Request for Architectural Review Board Agenda Item

| From: ALEXIS KISER, ASSISTANT TO CITY ADMINISTRATOR | | | | | |
|---|---|----------------------------|---------------------|---------|--------------------------|
| NEW CONSTRUCTION |)N - DOLLAR GE | NERAL - ST. JAN | 1ES AVE (HWY 176 |) | |

MEMORANDUM

RE: New Construction – Dollar General on St. James Ave (TMS# 223-13-04-002, -033)

A8

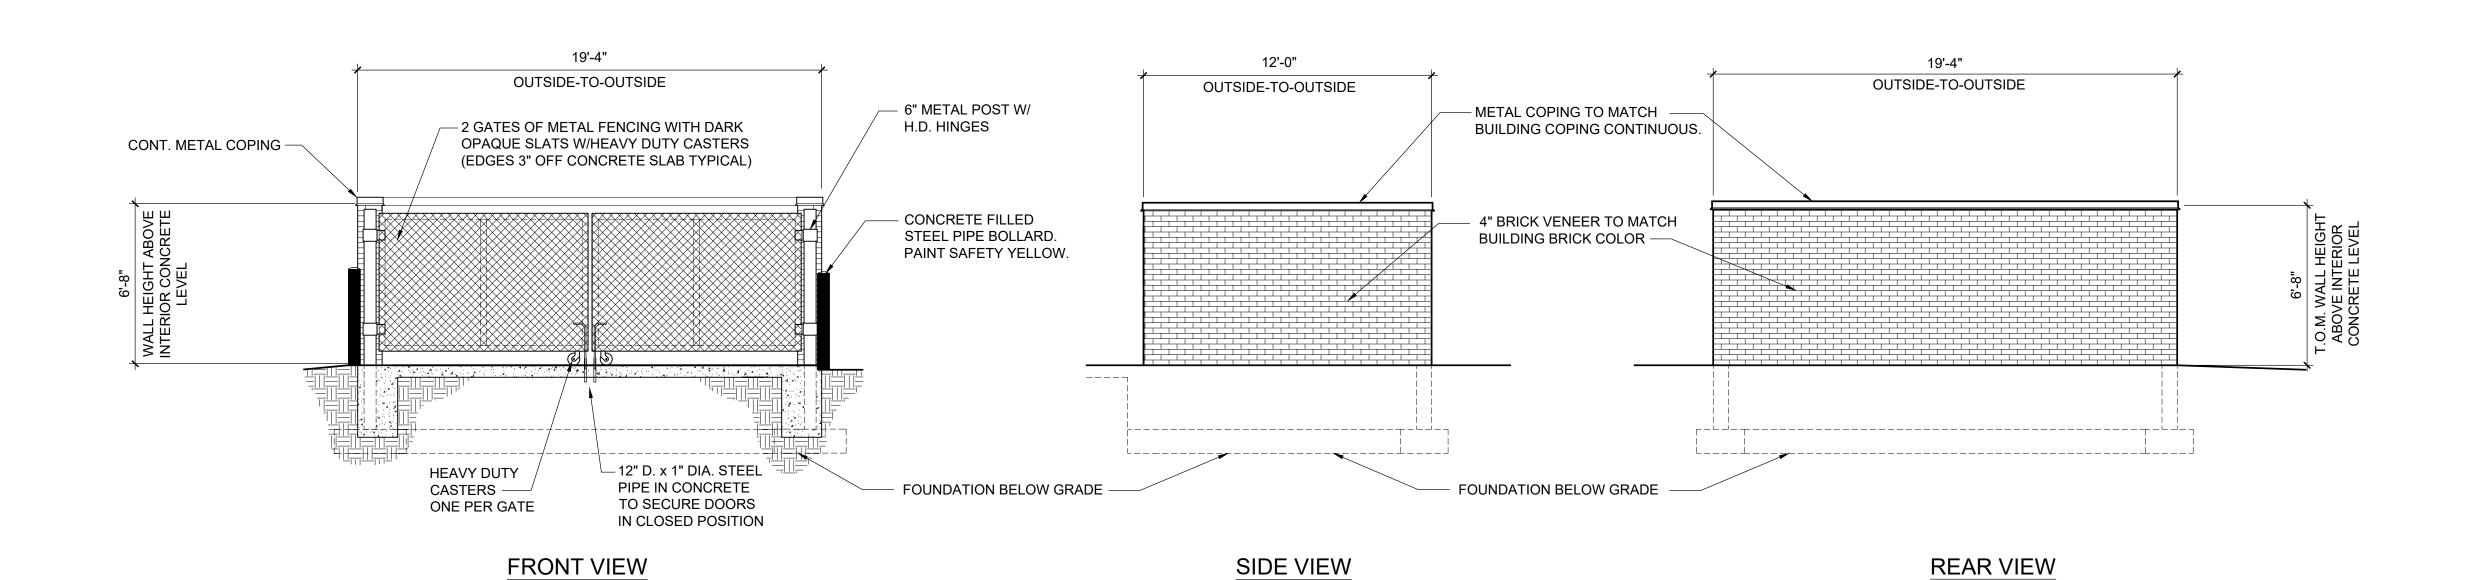
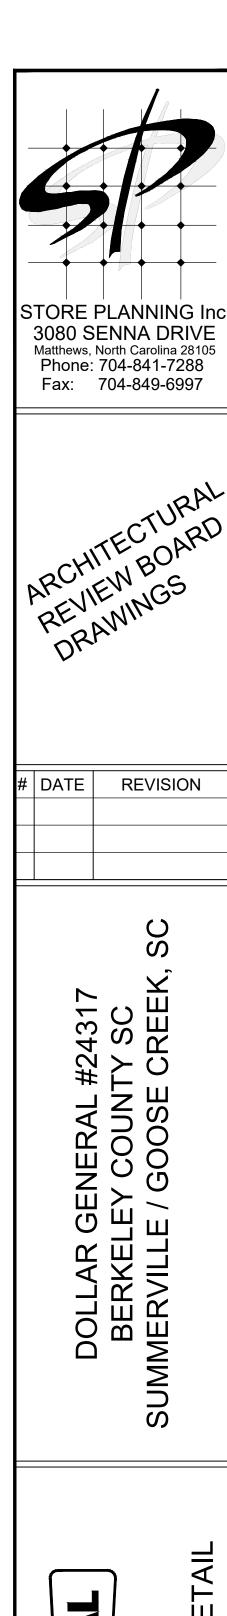
Staff would like to note that there are tree placements on the planting plan (Sheet L1) that are not shown in the renders of the proposed structure (sheets AR-1 and AR-2) and the render of the refuse enclosure (sheet A8). This is most likely as to not impede views of structures; however, it would be recommended to show this planting plan throughout all renders at lower opacity to keep continuity throughout application.
